Re: LeBreton Flats Library Parcel – 665 Albert Street, City of Ottawa
Booth Street and Albert Street NE Roadside Safety Assessment
TYLin Ref. 10399

MEMORANDUM

Attachment 1 – Roadside Safety Review Comment Drawing, Wet Well Swept Path Analysis Package, and Collision Report Summary

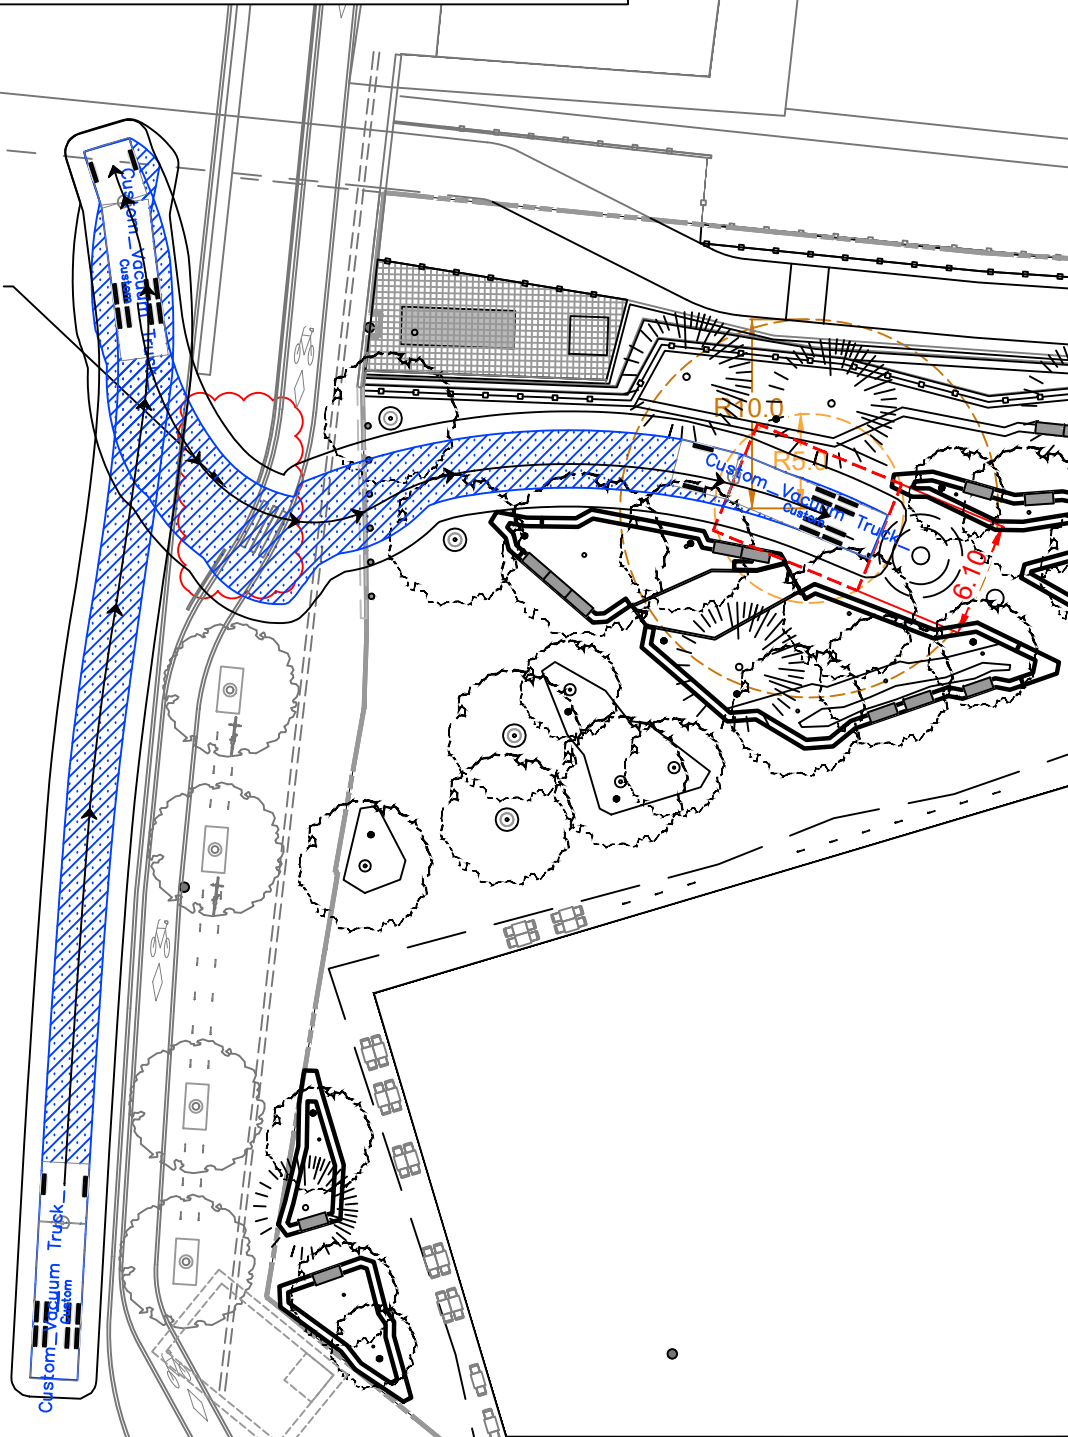
Recommend to install tall planter boxes to provide physical separation between the roadway and public realm.

Recommend hatched pavement along the curbside edge of the roadway to reduce the widths of driving lanes along Booth Street. Additional safety measure such as removable lane separators may be considered within the hatched area. Both recommended measures are low-cost solutions in lieu of full curb reconstruction, and would serve as traffic calming measures to slow vehicular speeds and enhance the safety of cyclists in the adjacent bike lane within the public right-of-way.

Consider installing Curb Reflectors along the curb radius to improve the visibility of the curb and entrance into a traffic-calmed roadway during low-light conditions.

TYLin recommends the installation of 6-7 removable bollards within the property line to enhance multi-modal safety within Pimisi Plaza and replace the existing function of the concrete parapet, which will be removed.

The bollards are required to be removable, to accommodate service vehicles which require periodic access along this route to the wet well. The truck swept path analysis is enclosed as a separate drawing for reference.

Bollards have been discussed with the Landscape Architect and are included in the landscape base plan. These may be designed to be visually consistent with the adjacent public realm.

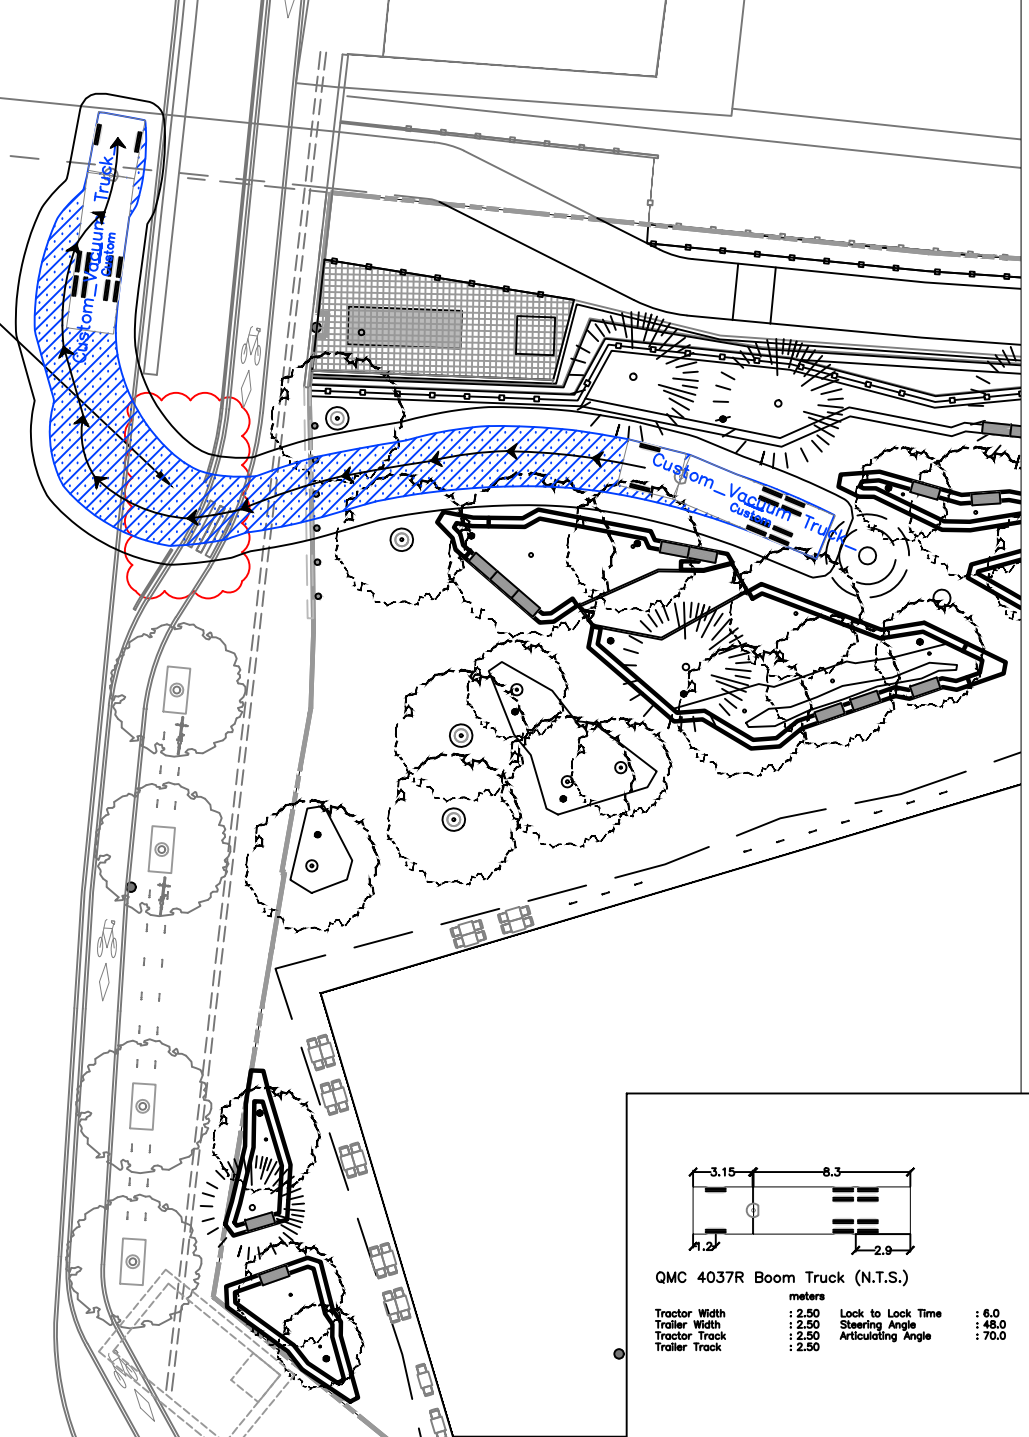
Please note that the design vehicle used for the simulation may be different than the operating vehicle. A custom boom truck was created based on the truck specs provided from their partners. Please confirm if the design vehicle's detail dimensions and specs corresponds to the operating vehicle on site.

- 1.0m horizontal buffer was considered throughout the truck swept path
- It is strongly recommended that trained staffs from the city or property management staffs be present to assist circulation of the service truck. The truck will reverse in to the pedestrian realm from a public road, therefore vulnerable users shall be warned during this operation.

Larger curb cut may be required to accommodate the service truck

Larger curb cut may be required to accommodate the service truck

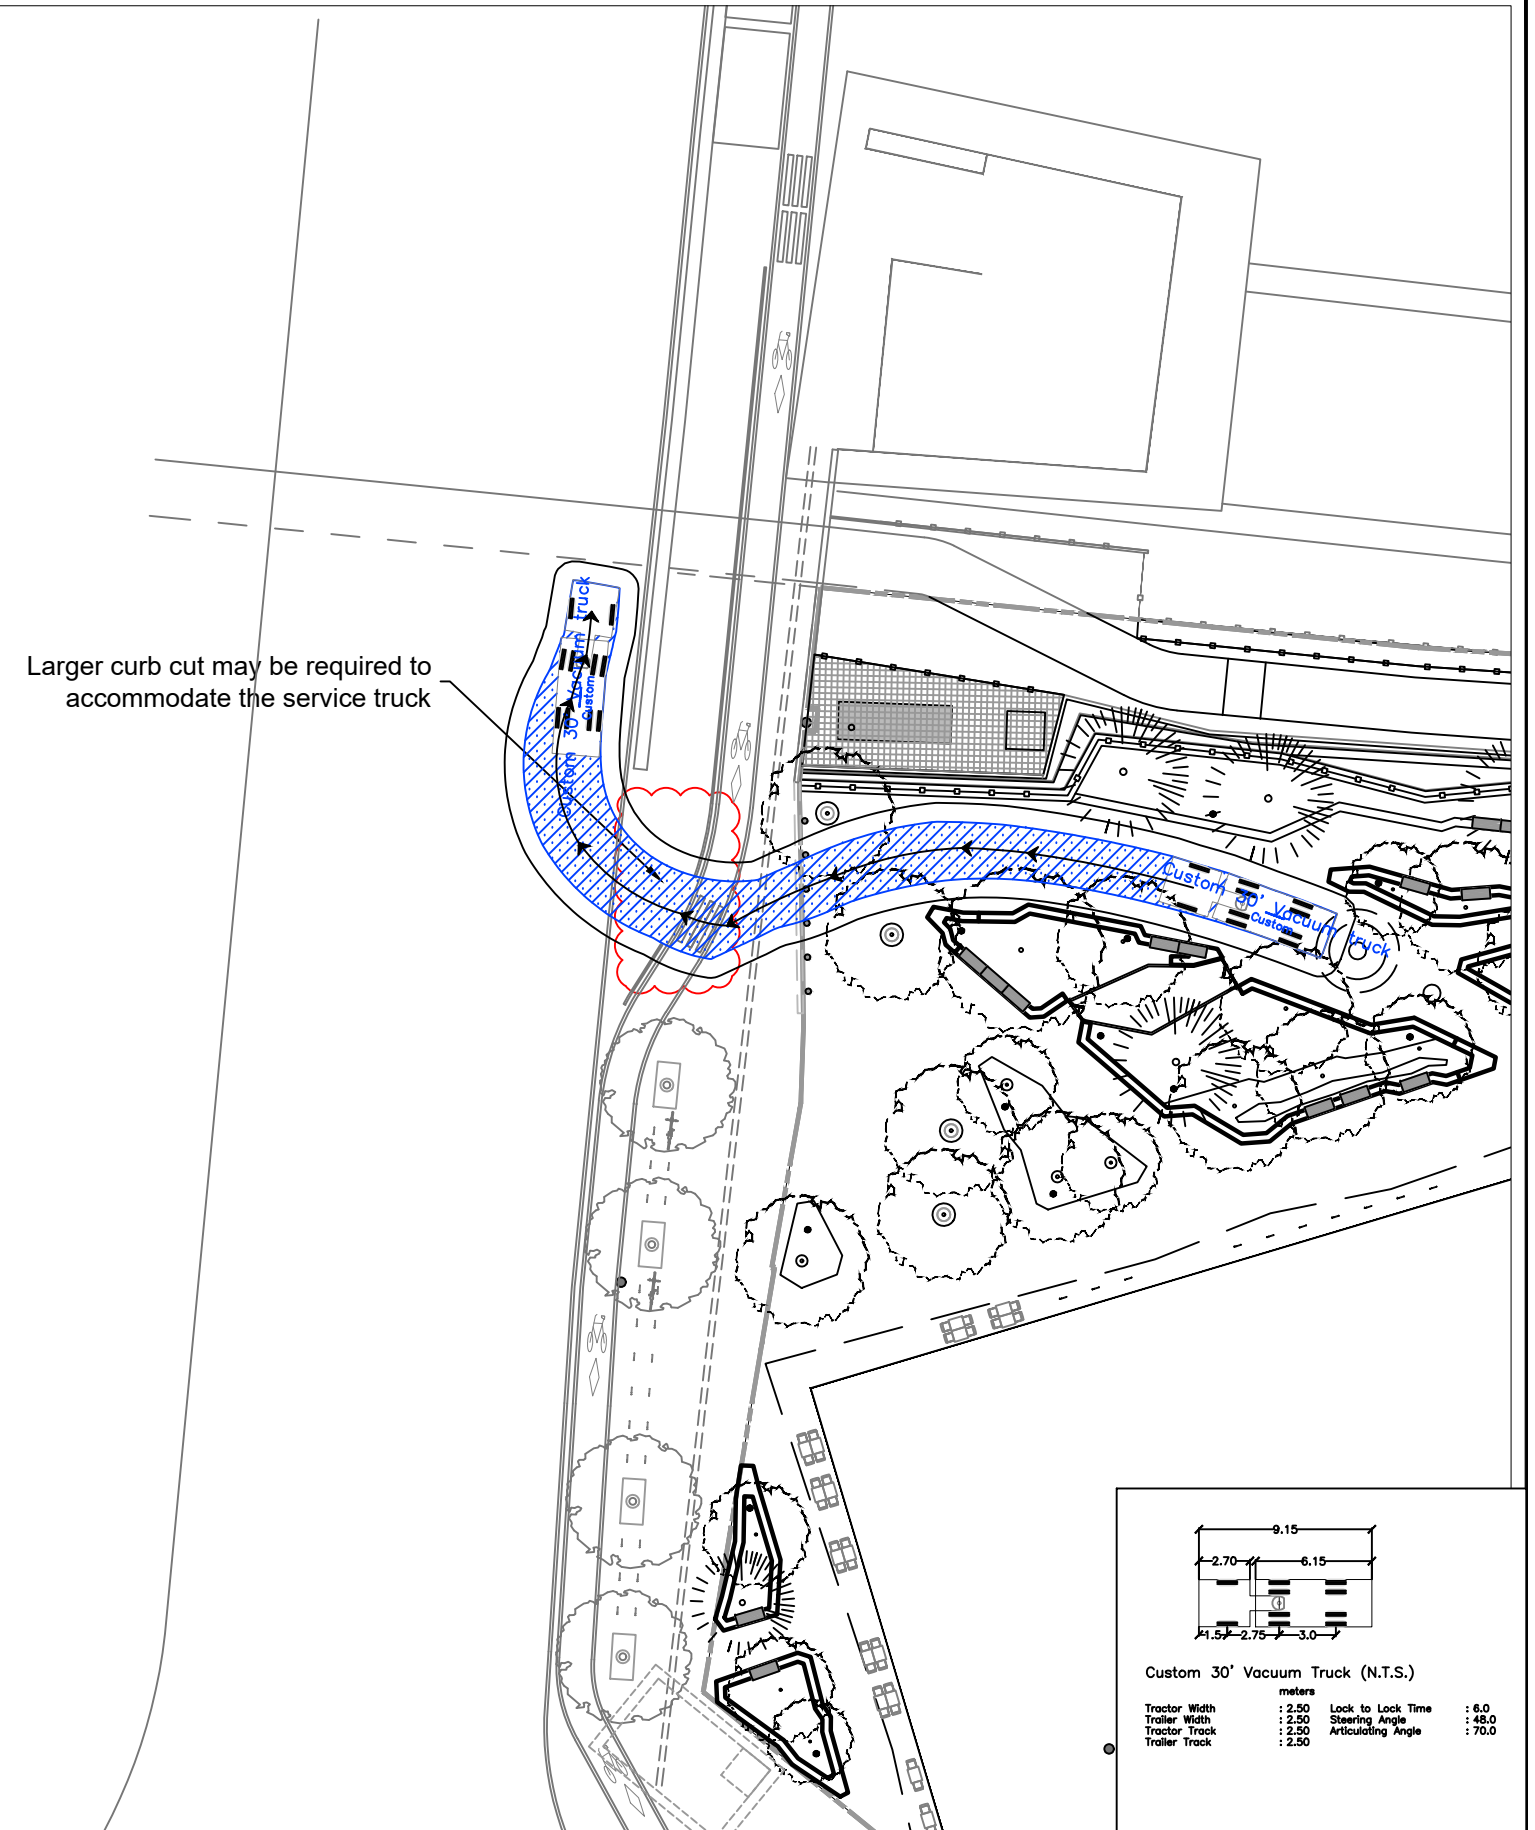
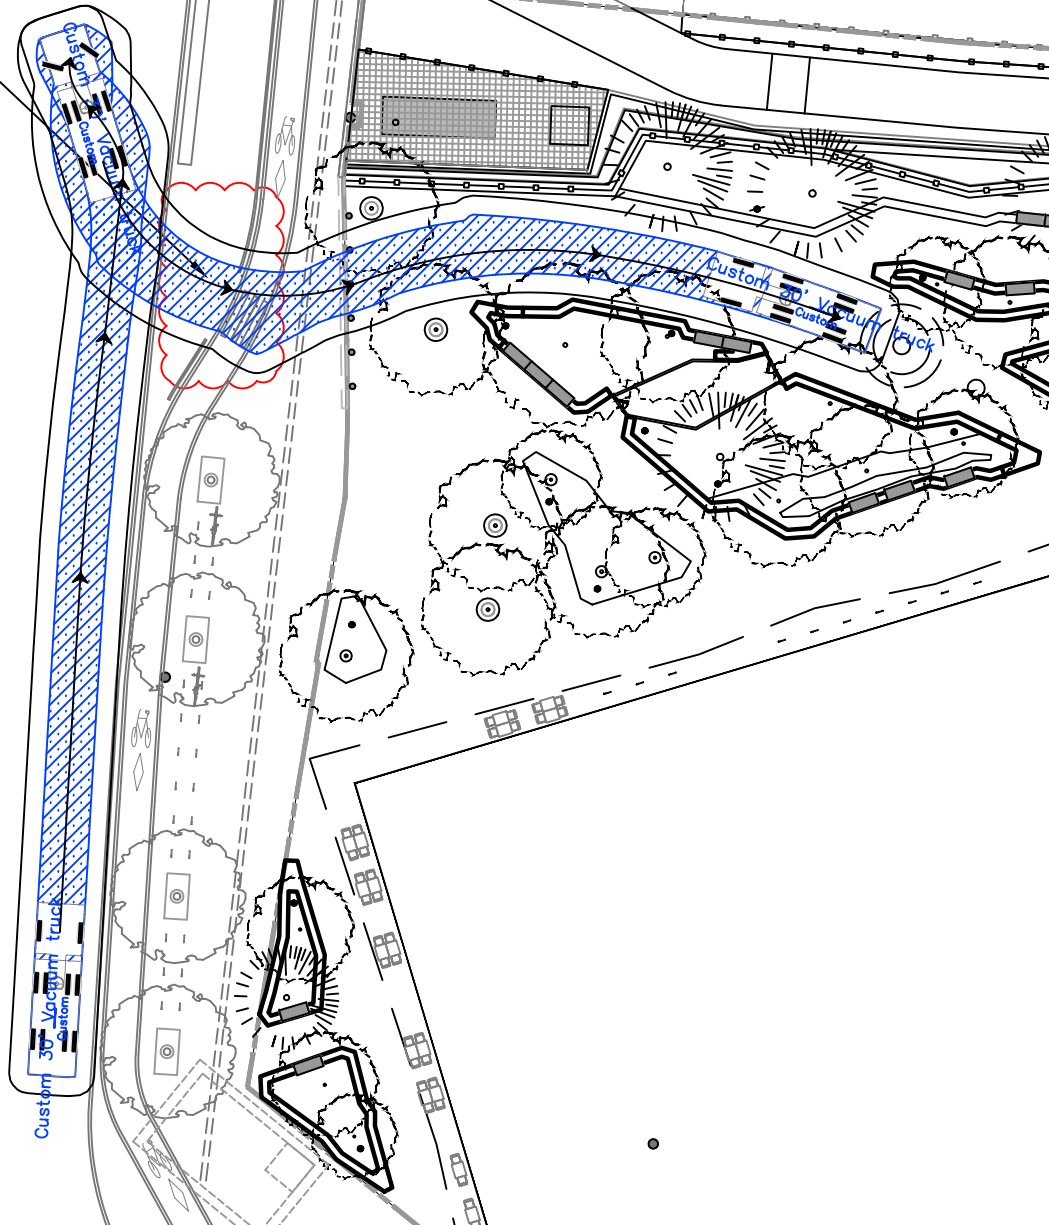
Please note that the design vehicle used for the simulation may be different than the operating vehicle. A custom vacuum truck was created based on the length of the truck provided by their partners. Please confirm if the design vehicle's detail dimensions and specs corresponds to the operating vehicle on site.

- 1.0m horizontal buffer was considered throughout the truck swept path
- It is strongly recommended that trained staffs from the city or property management staffs be present to assist circulation of the service truck. The truck will reverse in to the pedestrian realm from a public road, therefore vulnerable users shall be warned during this operation.

Larger curb cut may be required to accommodate the service truck

Larger curb cut may be required to accommodate the service truck
